**SPECIAL PROVISIONS  
FOR  
MULTI-COMPONENT LIQUID PAVEMENT MARKINGS**

**Adair County  
IMX-080-2(256)86--02-01**

**Black Hawk County  
IMX-380-7(130)55--02-07**

**Effective Date  
October 19, 2021**

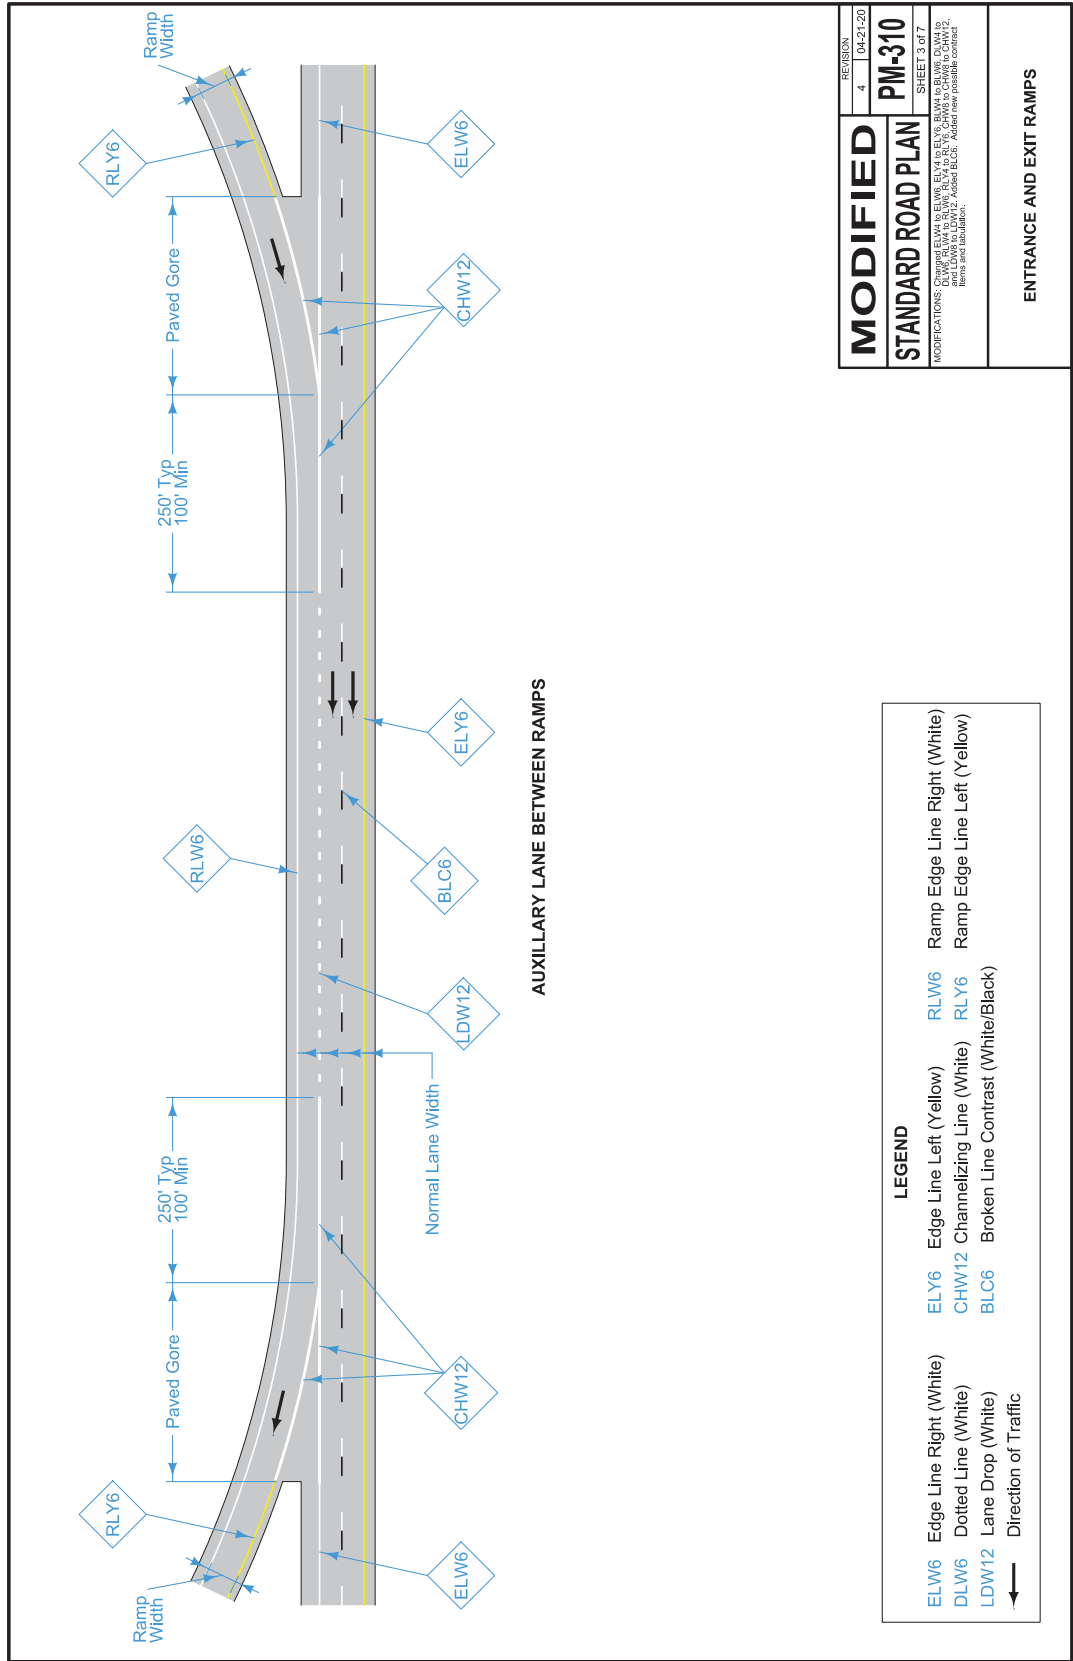
<table><tr> <td>REVISION</td> <td>3</td> <td>04-27-20</td> </tr><tr> <td colspan="3">MODIFICATIONS: Added BLWS, BLCS, SLWS, ELWS, BLWS, PLWS, DLWS, CLW12, and LDW12. Added new possible contract items and tabulation.</td> </tr></table>

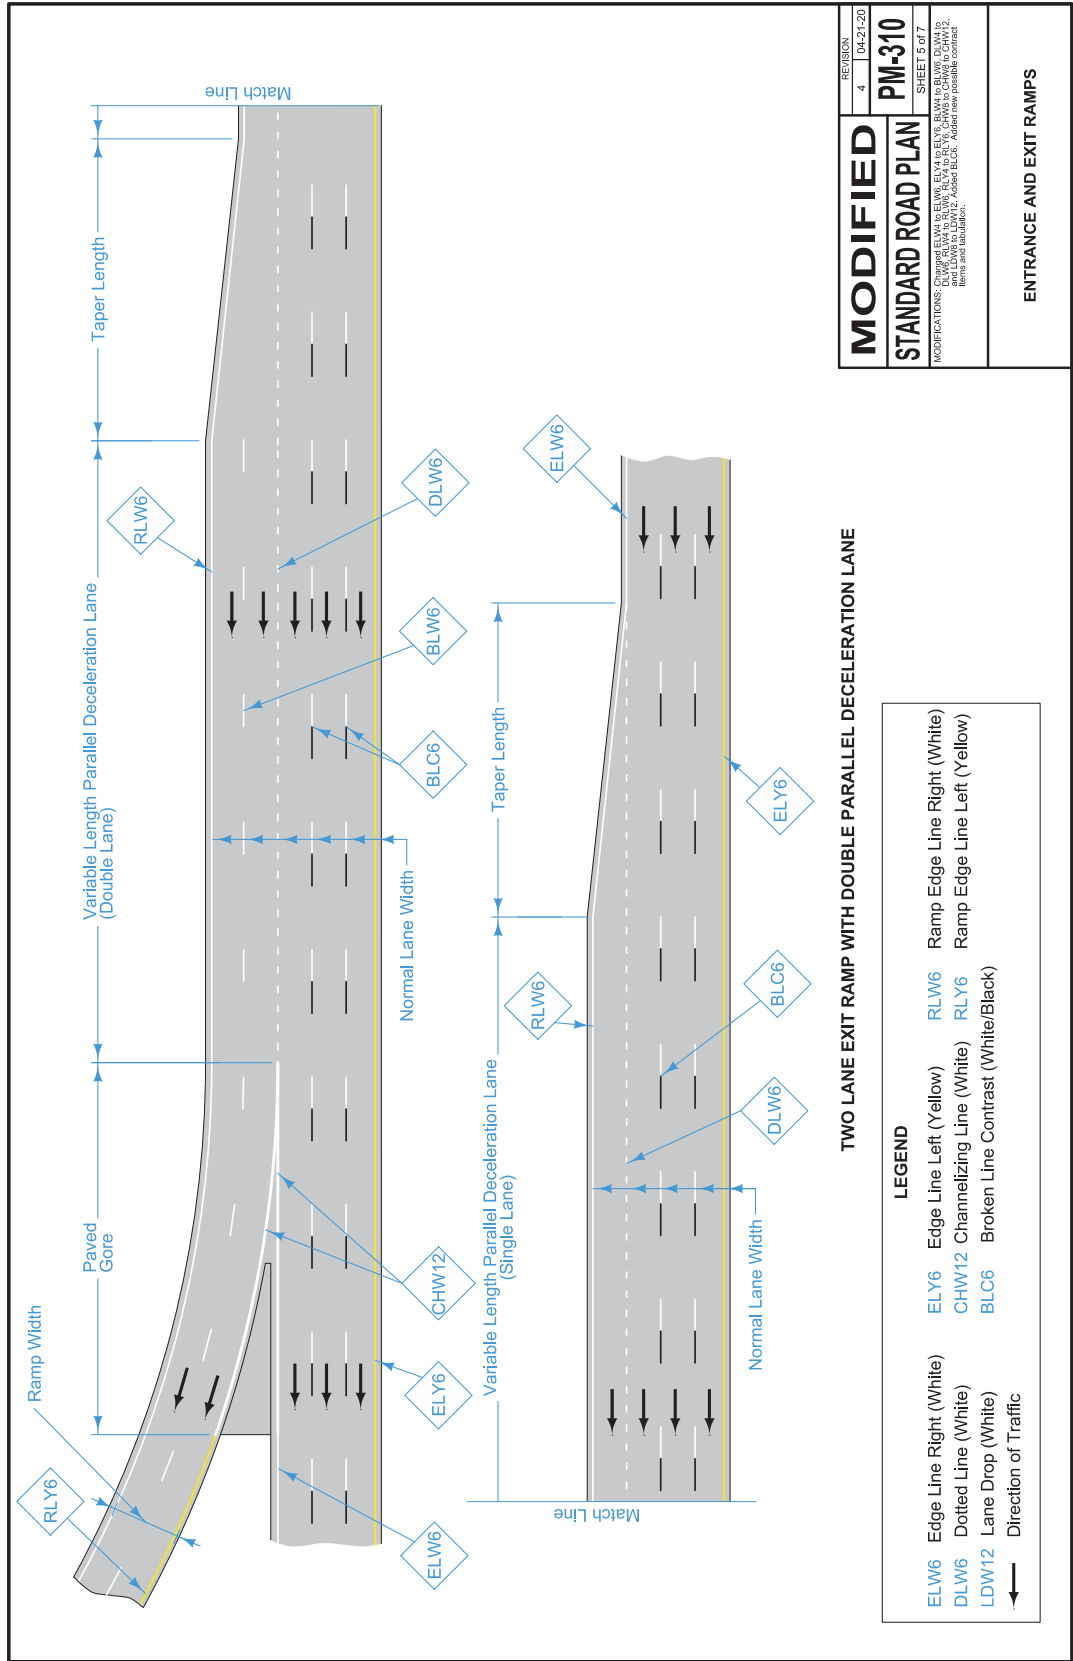
<b>MODIFIED</b>	REVISION 4	DATE 04-27-20
	<b>PM-310</b>	
<b>STANDARD ROAD PLAN</b>		
SHEET 3 of 7		
MODIFICATIONS: Changed ELW6 to ELW6, ELN4 to ELN4, BLM6 to BLM6, DMM6 to DMM6, RLY6 to RLY6, CHW12 to CHW12, BLC6 to BLC6, LDW12 to LDW12, RLM6 to RLM6, and added notes.		
<b>ENTRANCE AND EXIT RAMPS</b>

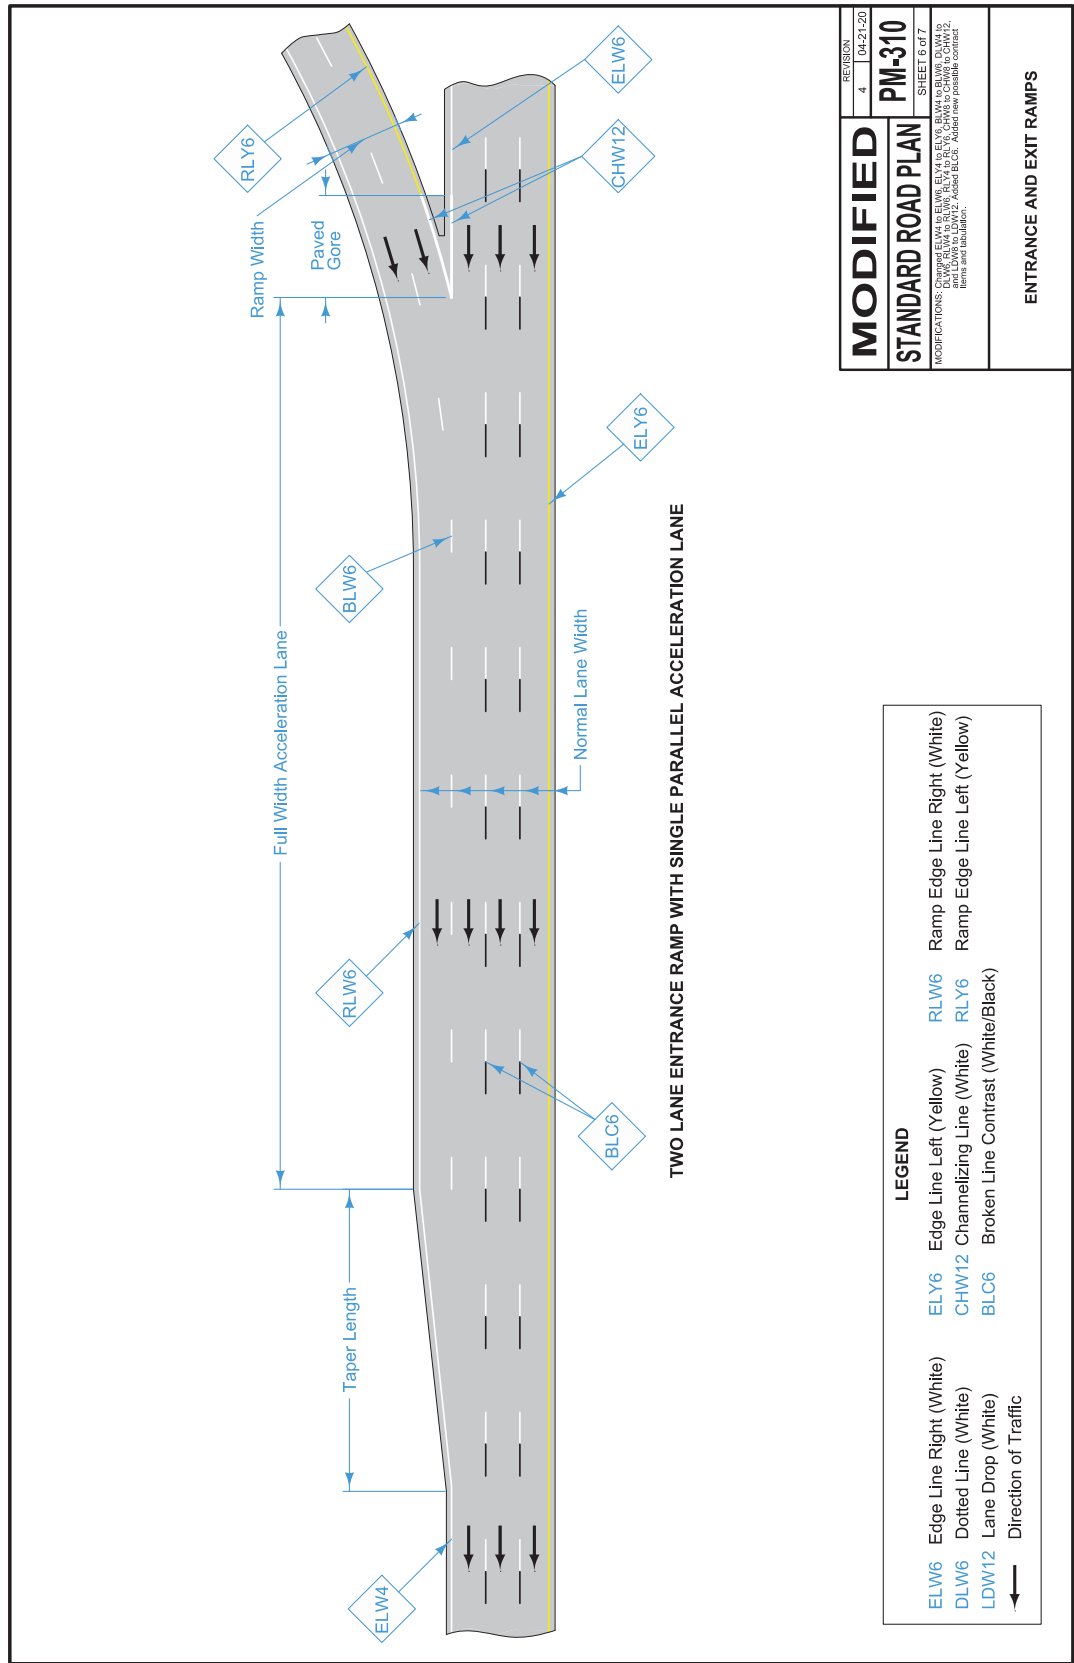
<b>MODIFIED</b>	REVISION	4	04-27-20
	<b>PM-310</b>		
<b>STANDARD ROAD PLAN</b>	SHEET 5 of 7		
<small>MODIFICATIONS: Changed ELW6 to ELY6, ELY6 to ELY6, BLY6 to BLW6, DLW6 to DLW6, RLY6 to RLY6, RLW6 to RLW6, CHW12 to CHW12, LDW12 to LDW12, BLC6 to BLC6, Added new private contract items and fabrication.</small>			
<b>ENTRANCE AND EXIT RAMP</b>
